PROJECT: Shimmah West Village 22 - Kettle Rise Way  
(from Kettle Bend Rd. to Desert Foothills Blvd.)

| <b>INTER-OFFICE MEMORANDUM</b>                                                                  |                                      | February 27, 2020                                                                                 |
| <b>SUBJECT:</b>                                                                                 | Drainage Study for:                  | <b>COPIES TO:</b>                                                                                 |
| Summerlin West Village 22 - Kindle Rise Way<br>(from Kettle Bend Rd. to Desert Foothills Blvd.) |                                      | VTN Nevada                                                                                        |

**MUTW**

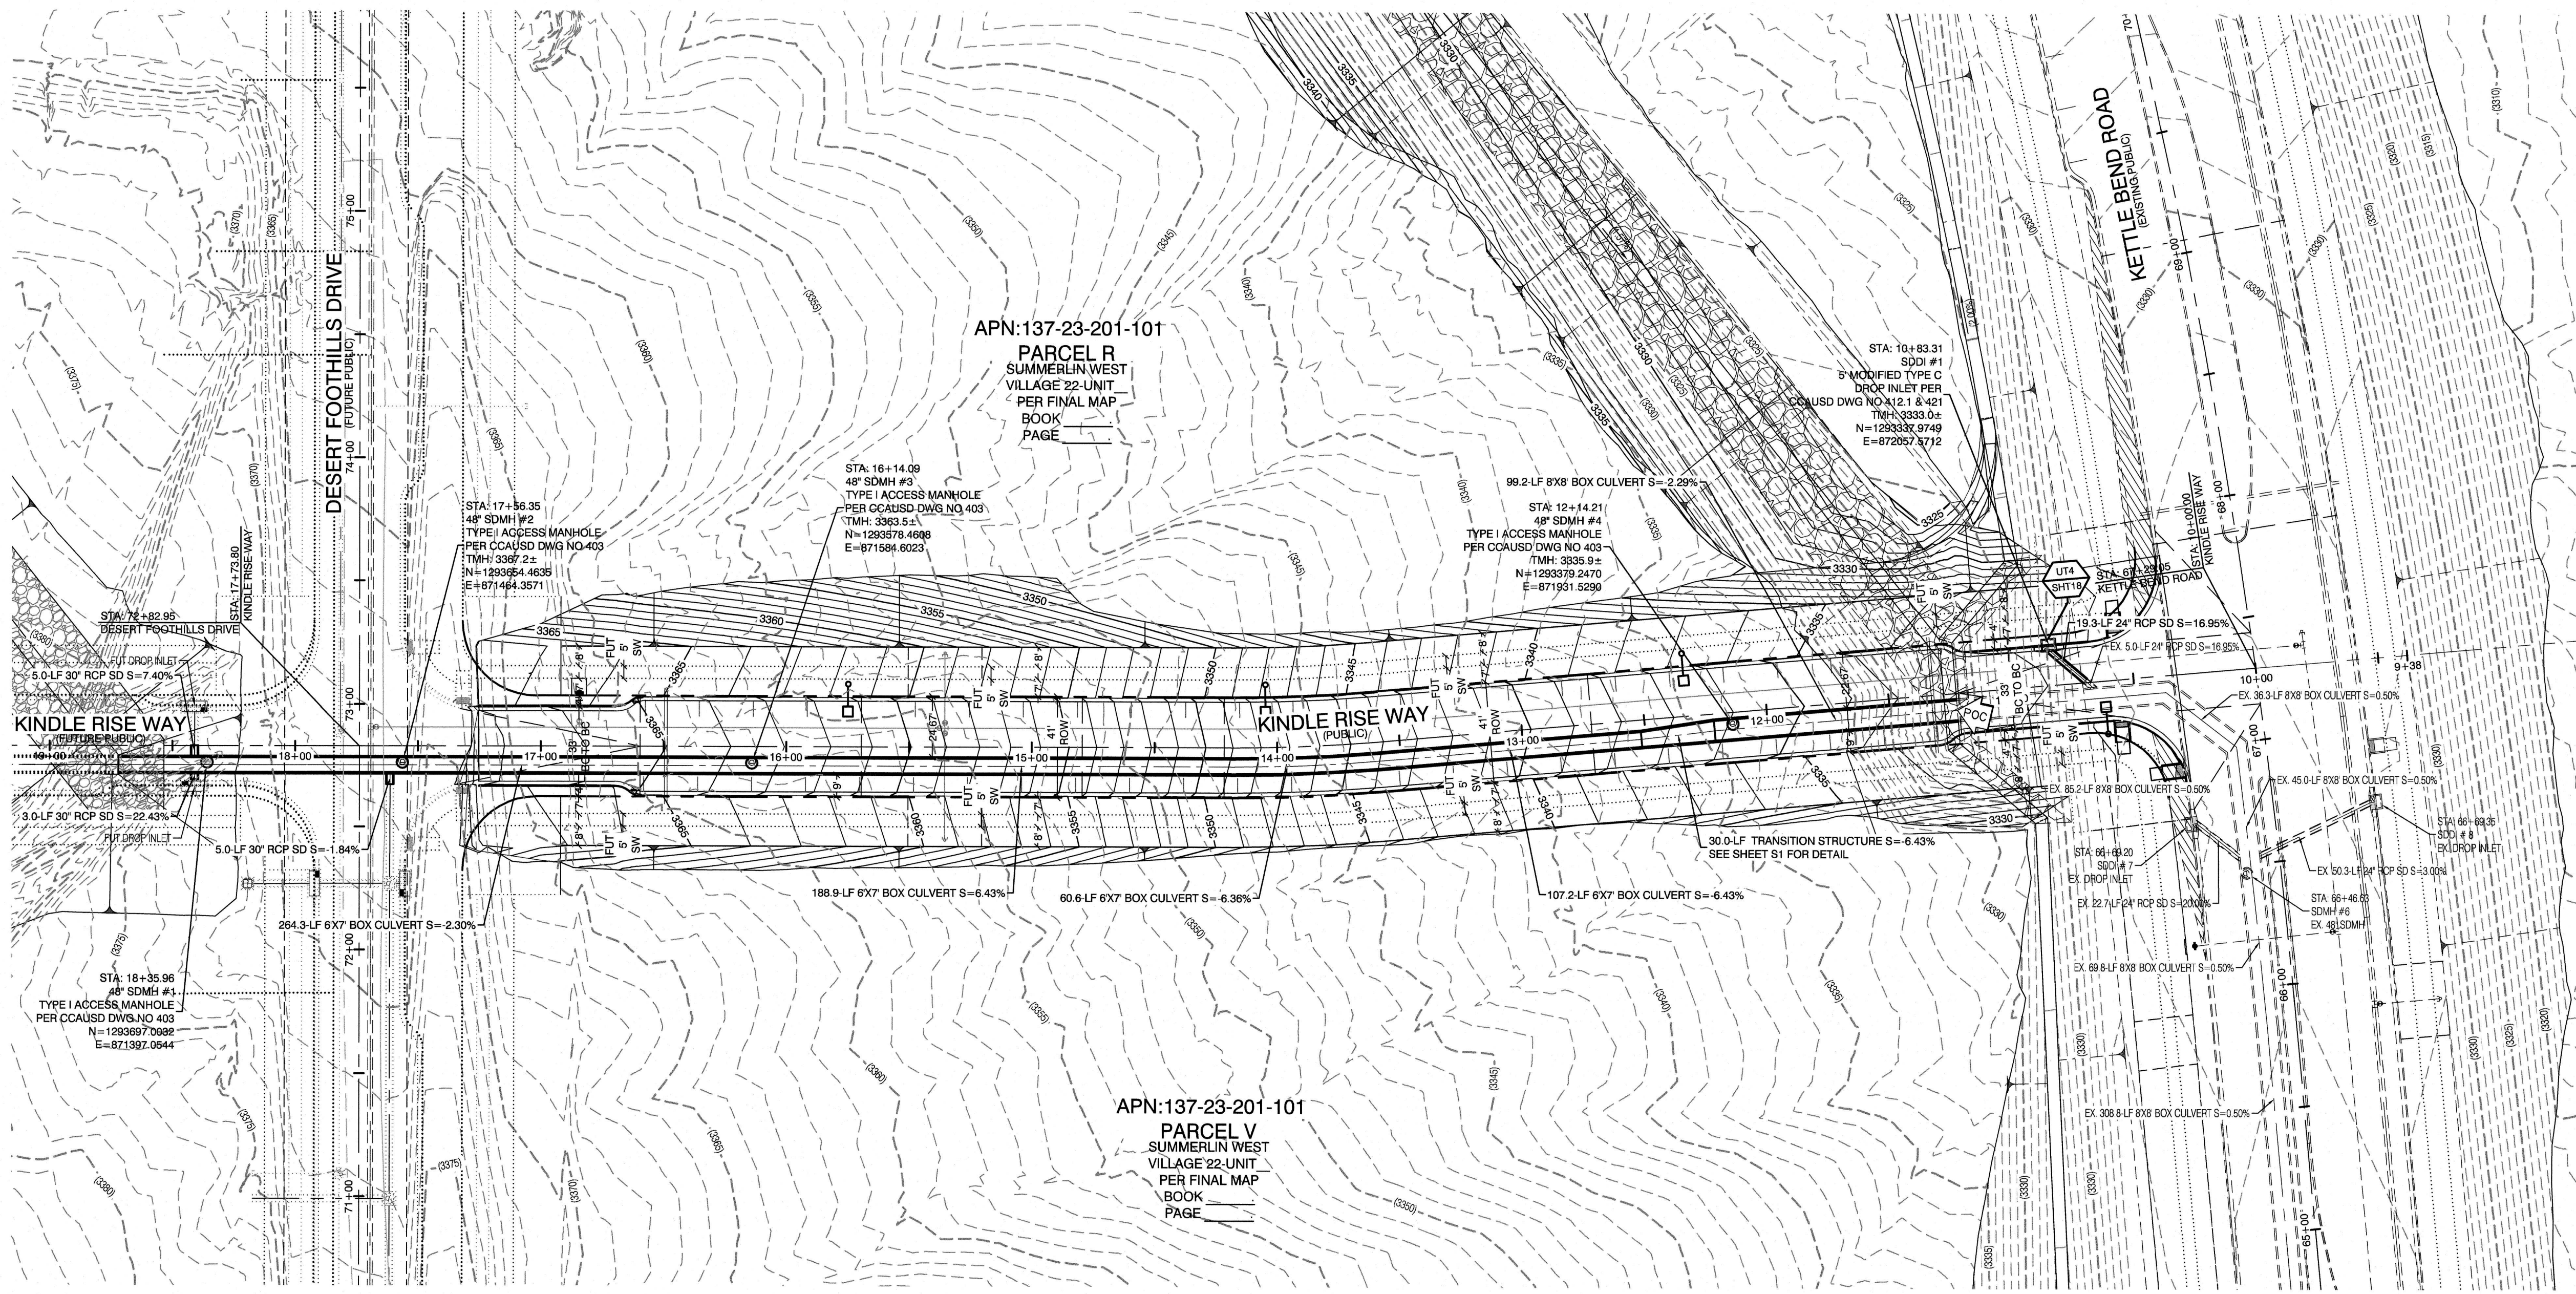
5. Provide a headwater elevation calculation for the RCB inlet using a model such as HY-8.
6. **Sheet MUTSD:** The graphic scale of 1"=20' is wrong which should be 1"=40'. Review and revise accordingly.

UTILITY PLAN & PROFILE 2  
14+30 TO 9+38  
SUMMERLIN WEST VILLAGE 22  
KINDLE RISE WAY-KETTLE BEND  
ROAD TO DESERT FOOTHILLS DRIVE

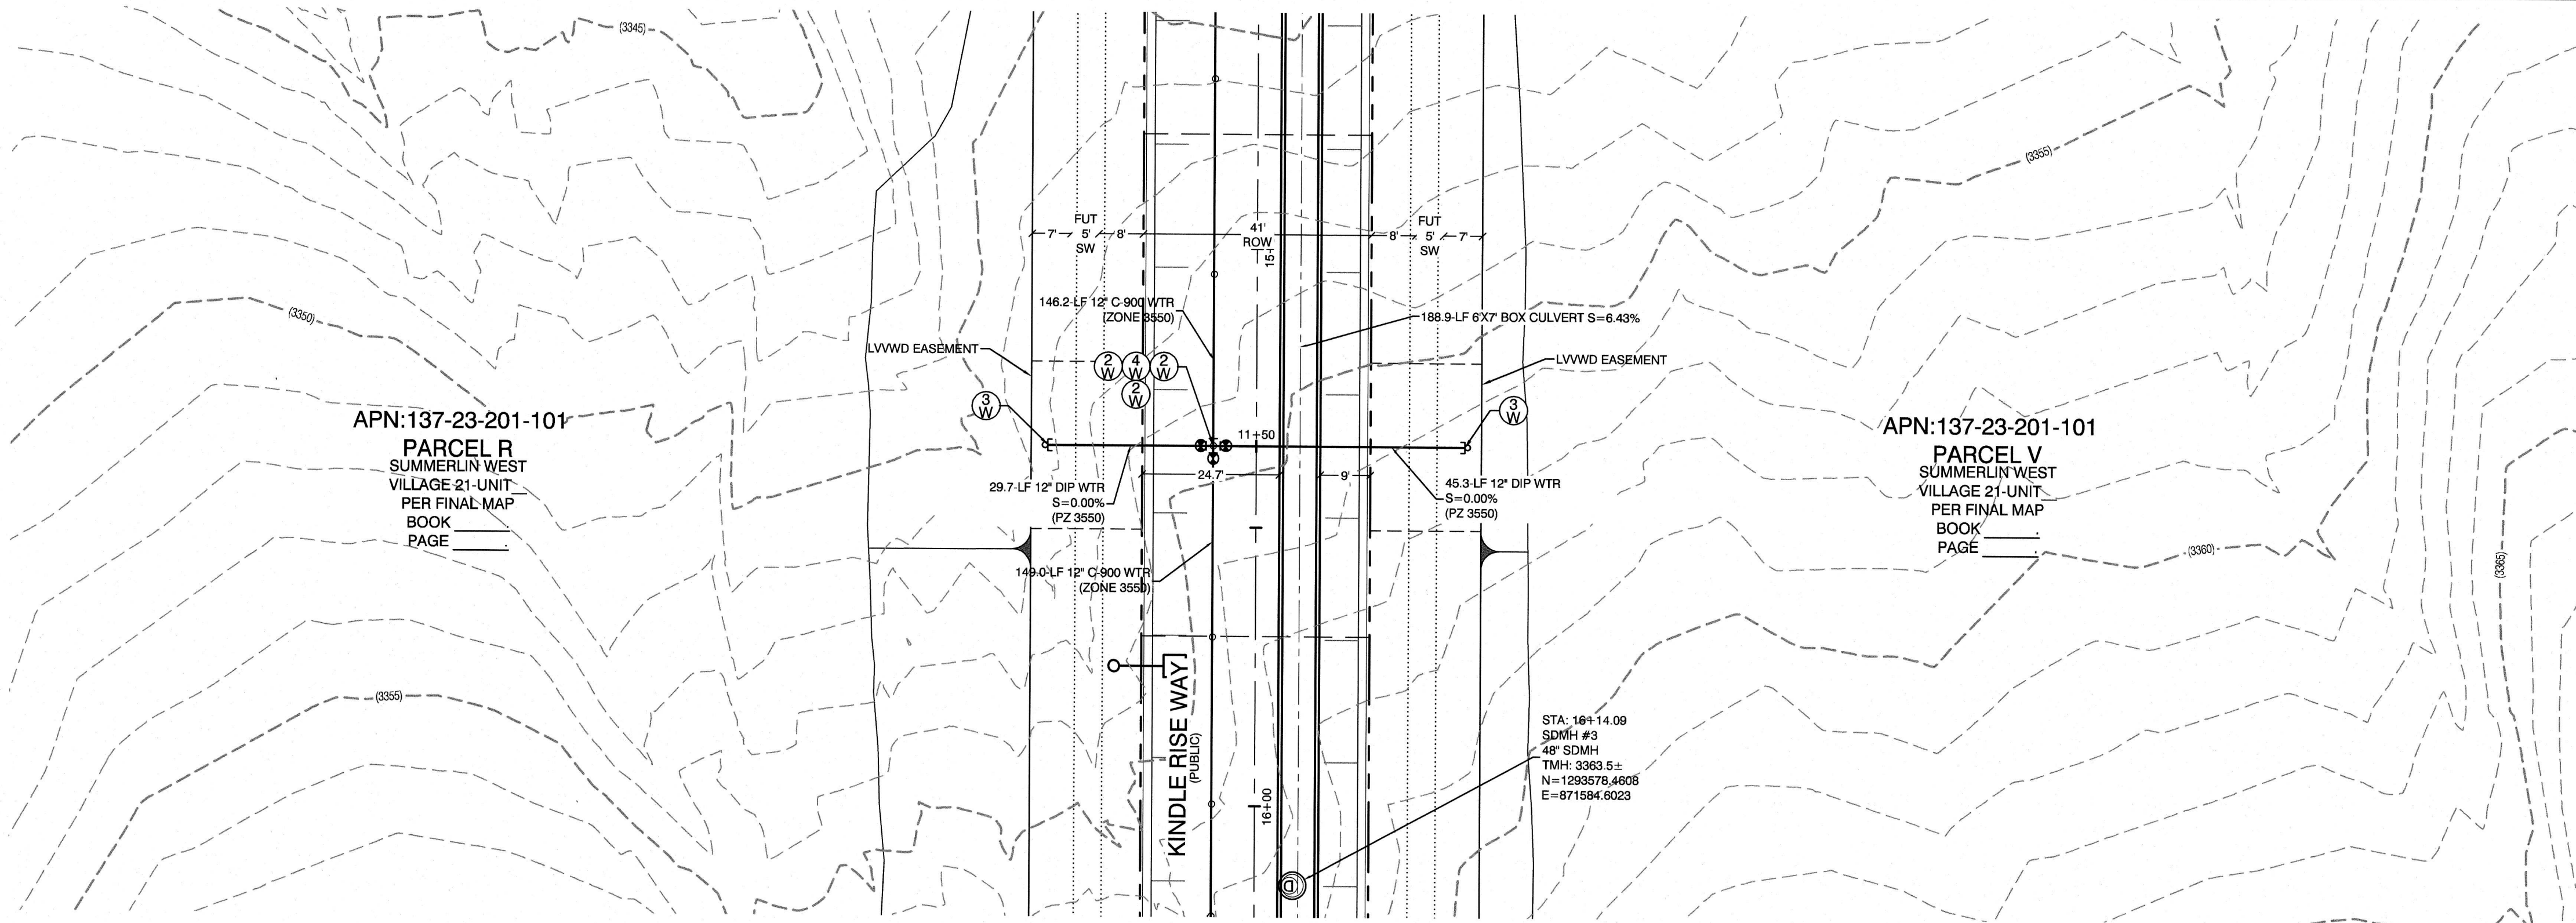
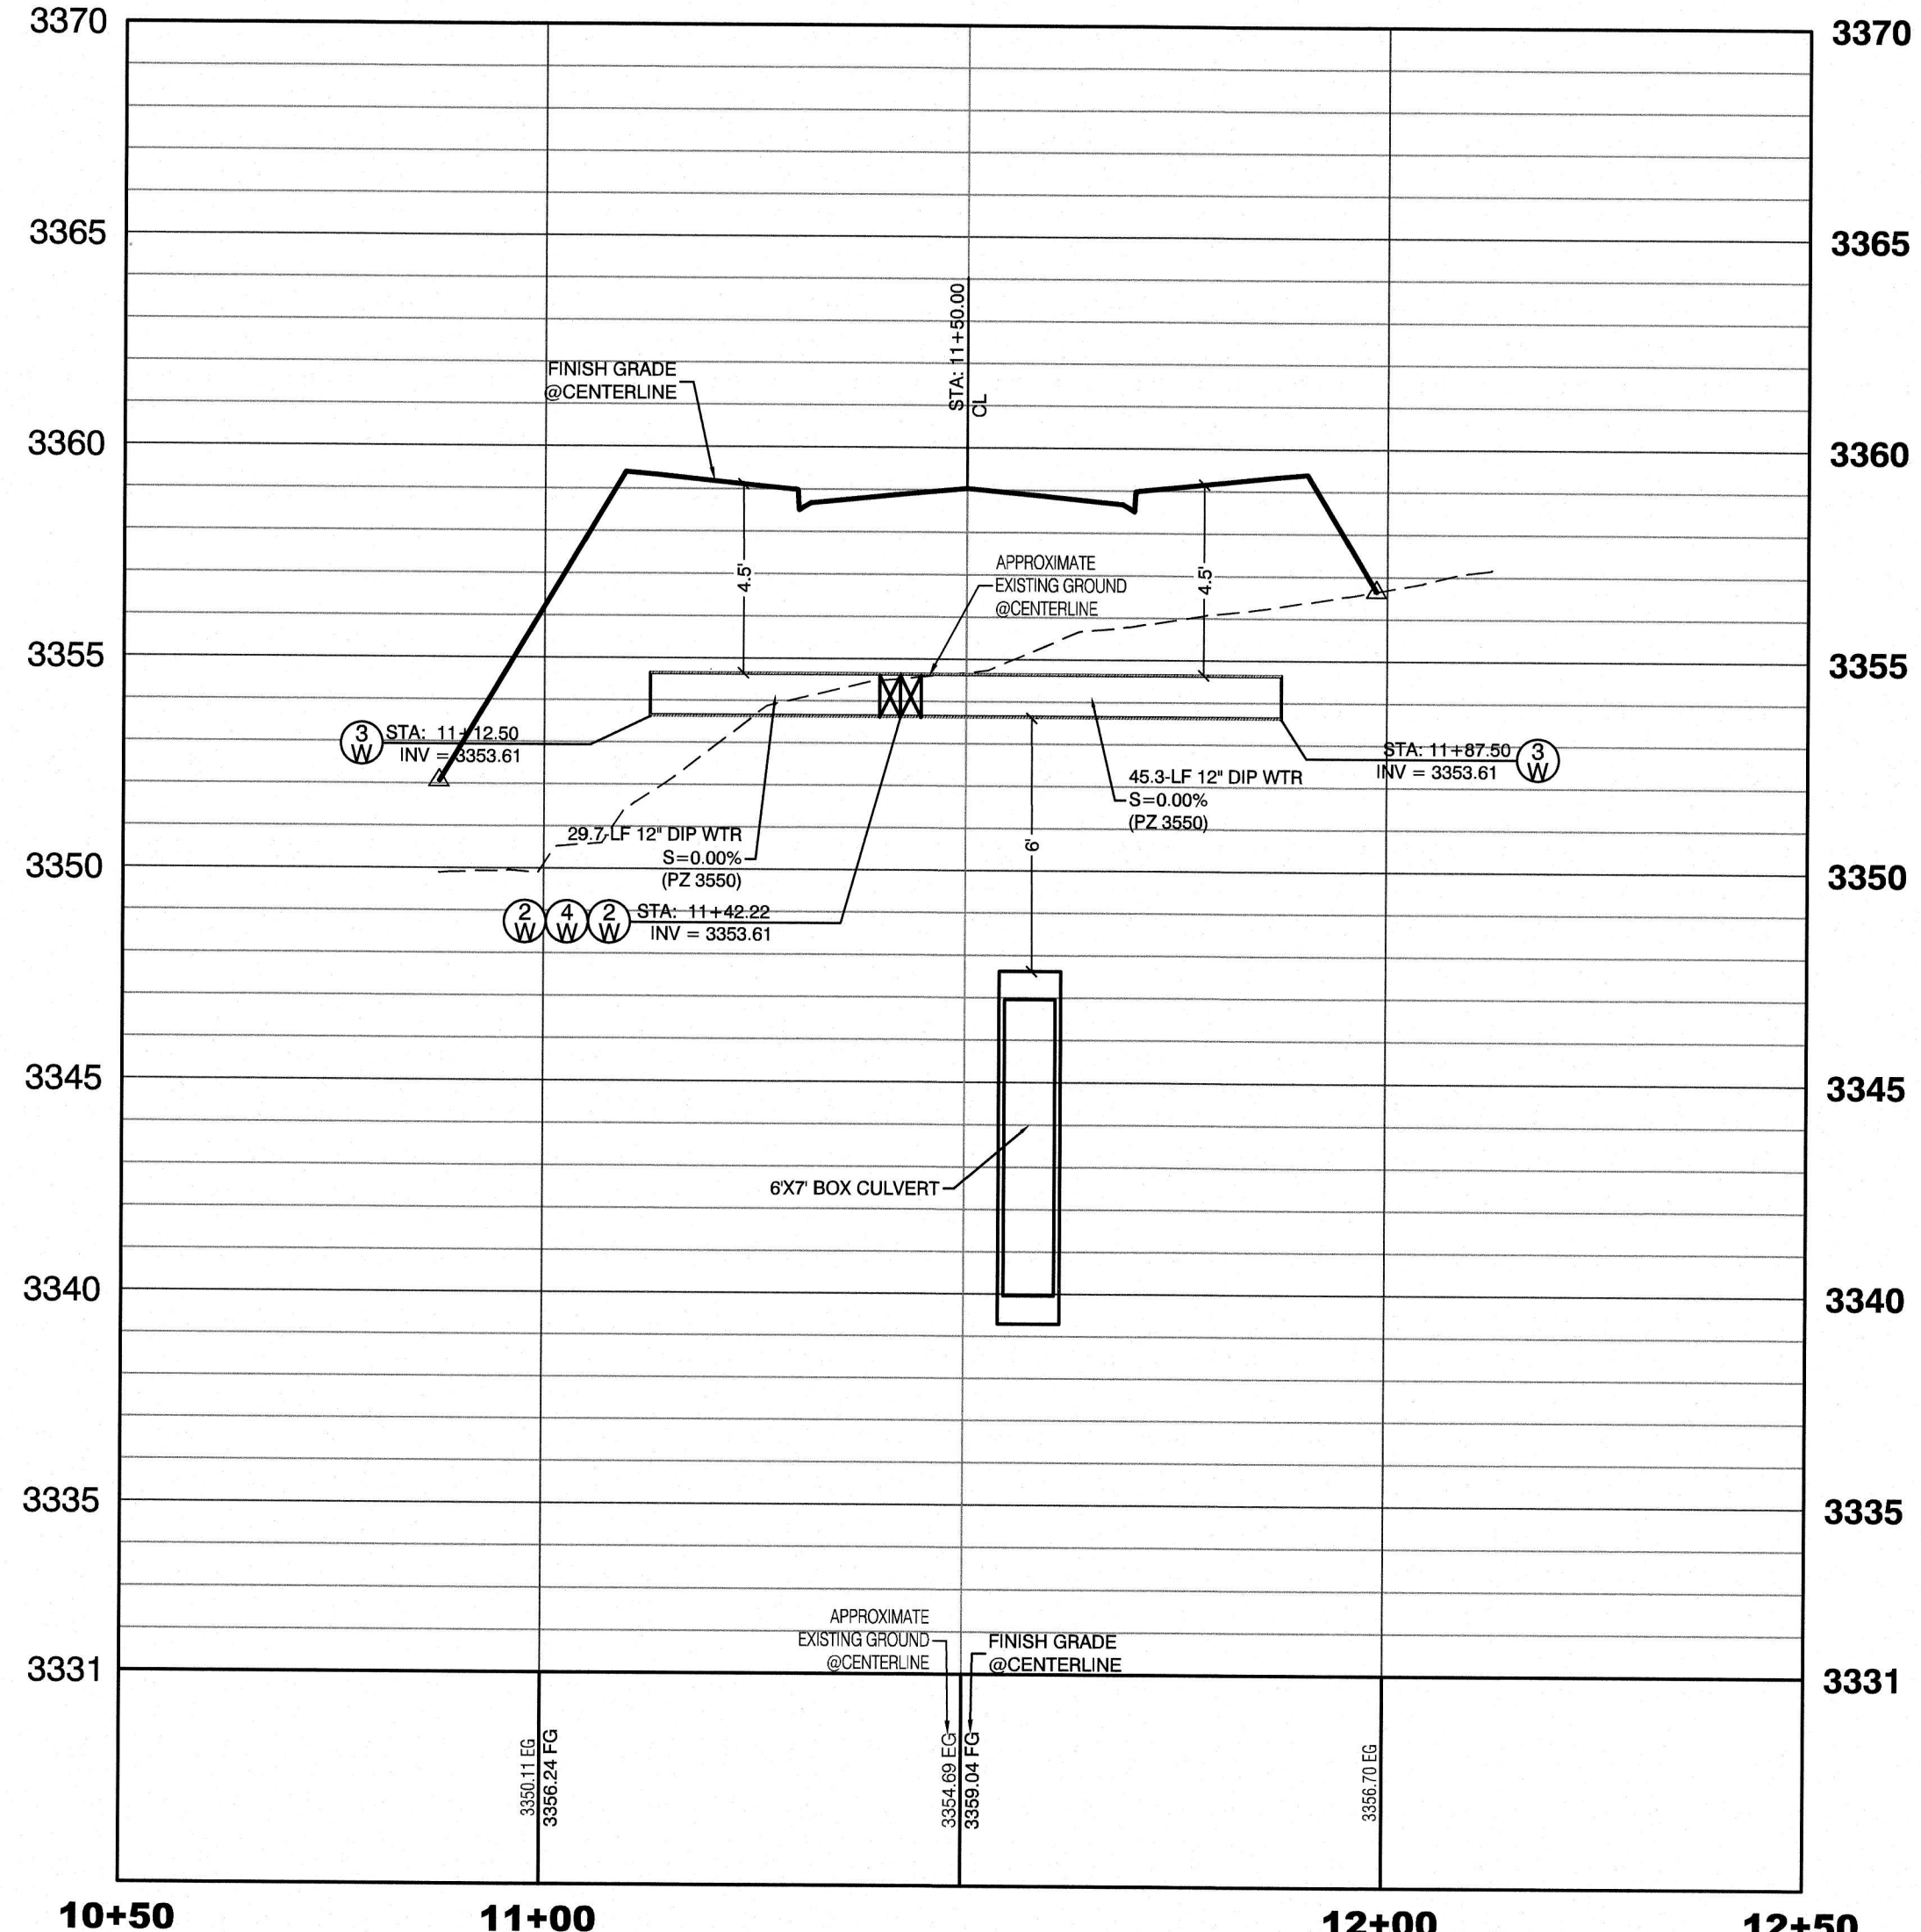
7. **Sheet UT1:** Provide a nuisance inlet on each side of *Kindle Rise Way* at approximate Station 17+00.
8. **Sheet UT2:** Provide a transition structure between the 6'x7'-RCB and the 8'x8'-RCB. UT2 calls out a transition structure shown on sheet S1. Sheet S1 is not provided. Detail structural designed transition structure shall be provided in the next submittal.

9. **Sheet UT2:** A connection detail between an existing and a new box must be provided at Station 11+22.50 in *Kindle Rise Way*.
10. All special structures including the transition structure and mainline storm drain connection require details and structural calculations to be reviewed by the *City of Las Vegas Building & Safety Department*. Approval by the *Building Department* must be obtained prior to the final approval of the subject drainage study.

11. **Sheet UT2:** Provide a nominal inlet at the south side of *Kindle Rise Way* at approximate Station 11+50.
12. In all pertinent lateral plan & profile sheets, label the depth of the proposed drop inlets. All storm drain inlets that are more than 10'-deep require a special structural detail and calculations. Submit structural design and calculations to *City Building & Safety Department* for review and approval prior to the final approval of the drainage study.
